Our Case Number: ABP-317767-23

Re: Proposed construction of 39 residential units, widening of Pausdeen Bridge and all associated site works.
Newtown/Ardclough Road, Newtown, Celbridge, Co. Kildare.

Planning Observation Submissions to An Bord Pleanála

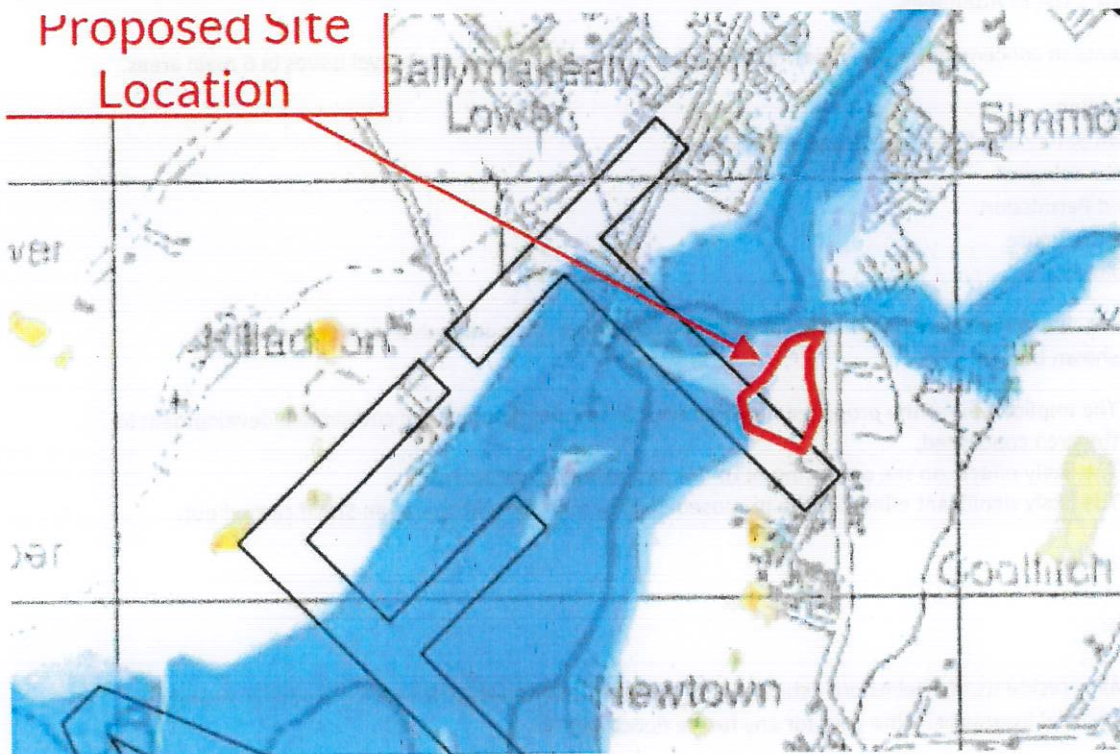
Very little tolerance: The predicted high water level of the site at 09L1FF02820 and 0.1% AEP is 52.95m. However evidence shows water further into the site. The Topographical survey indicates a Northwestern Fall

with levels varying from 53.80 to 53.0m OD at the Northwestern Edge. Are we to assume therefore that it was the illegal dumping which has helped to raise the site? Also 5cm clearance from a map without empirical current site data is hardly reassuring as good tolerance to flooding.
